State of California – Natural Resources Agency  
DEPARTMENT OF FISH AND WILDLIFE  
Central Region  
1234 East Shaw Avenue  
Fresno, California 93710  
(559) 243-4005  
[www.wildlife.ca.gov](http://www.wildlife.ca.gov)

April 12, 2021

**Subject: California High-Speed Rail Project, Bakersfield to Palmdale Section  
(Project) Revised Draft Environmental Impact Report/Supplemental Draft  
Environmental Impact Study (RDEIR/SDEIS)  
SCH No. 2009082062**

**Figure 1**

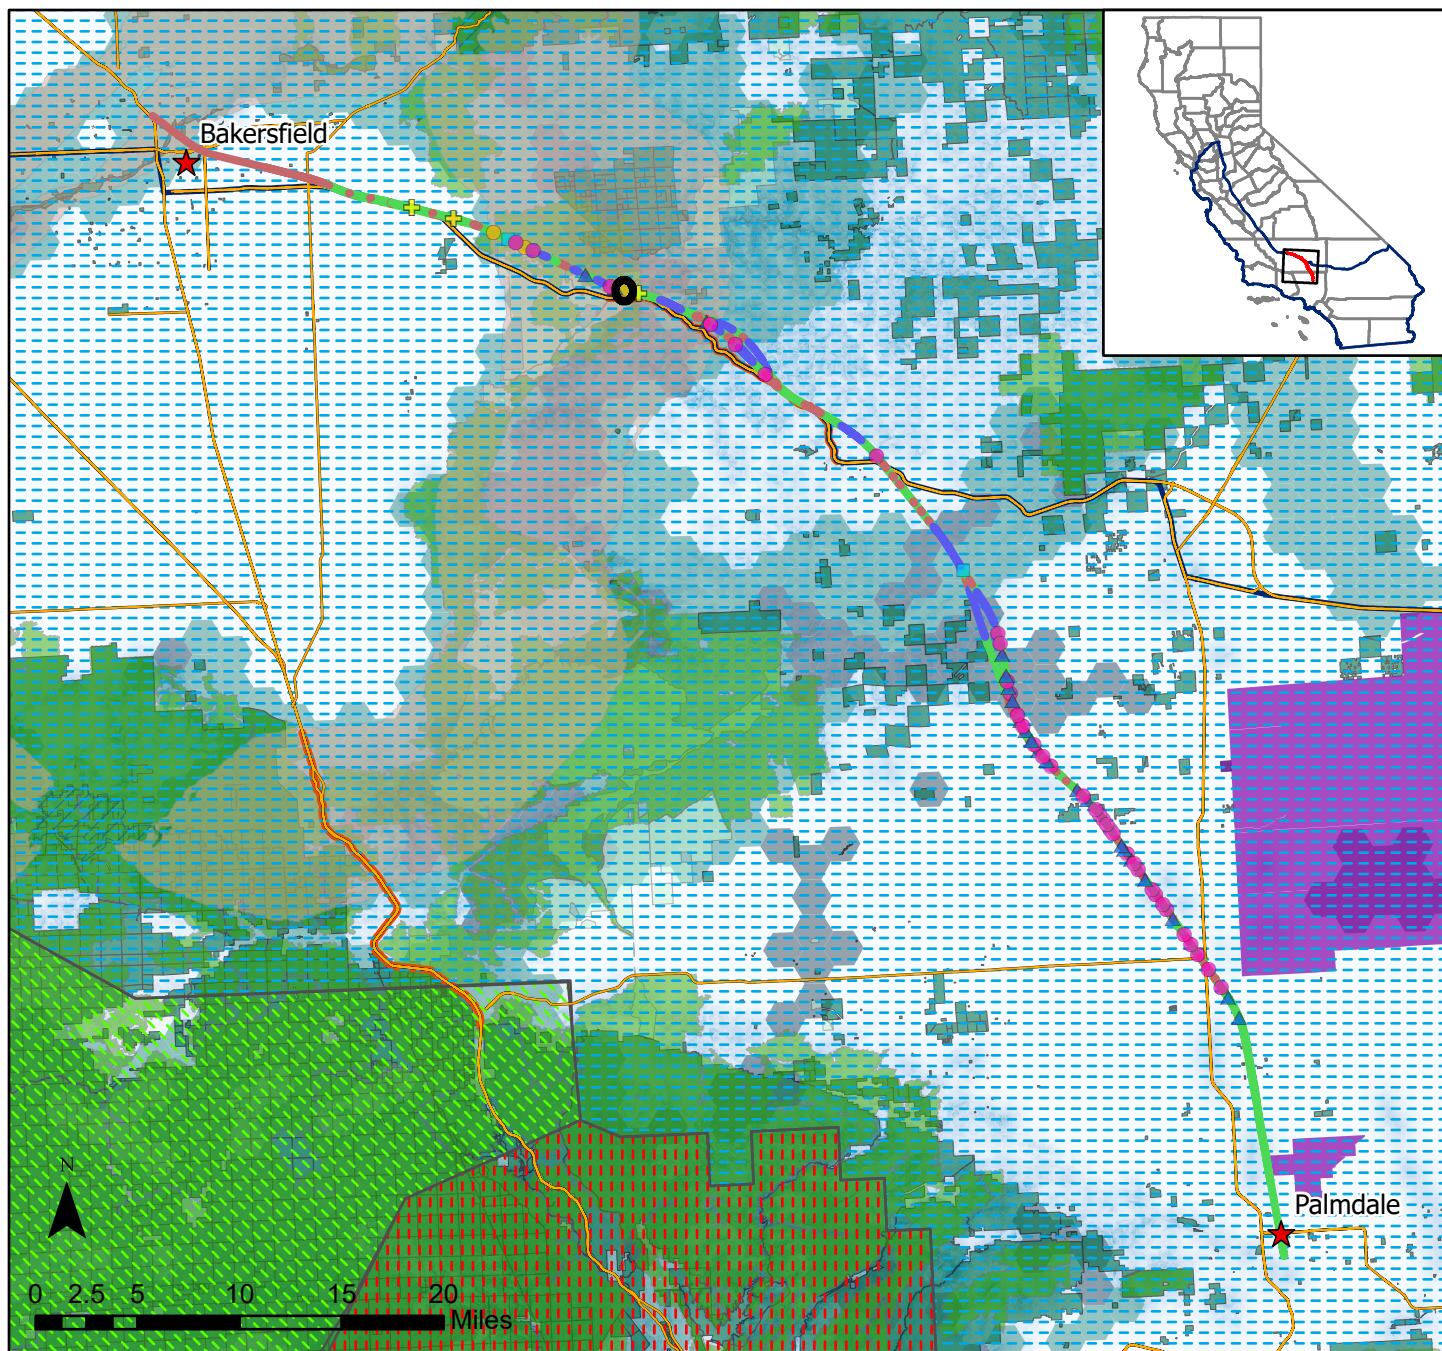
avoidance, minimization, and mitigation measures to reduce impacts to these isolated subpopulations providing connectivity for WSN mountain lion population to less than significant. CDFW recommends referencing the attached mapping (Attachment 1) for analysis.

There should be no net loss of suitable habitat for mountain lions. CDFW recommends that the Authority identify opportunities for the Project to enhance nearby areas and create movement opportunities including wildlife corridor restoration or enhancement as potential mitigation strategies. Since the RDEIR/SDEIS assumes wildlife movement and corridor impacts, the inherent loss of gene-flow, cannot be avoided between the subpopulations, thus the Authority must ensure some level of conservation is present in the areas that provide connectivity. CDFW recommends improving habitat connectivity (e.g., wildlife road-crossing structures) to facilitate unimpeded wildlife movement and gene-flow between adjacent areas of the WSN. CDFW recommends the replacement habitat be located adjacent to the Project and Wildlife Linkage and Corridor, see Attachment 1.
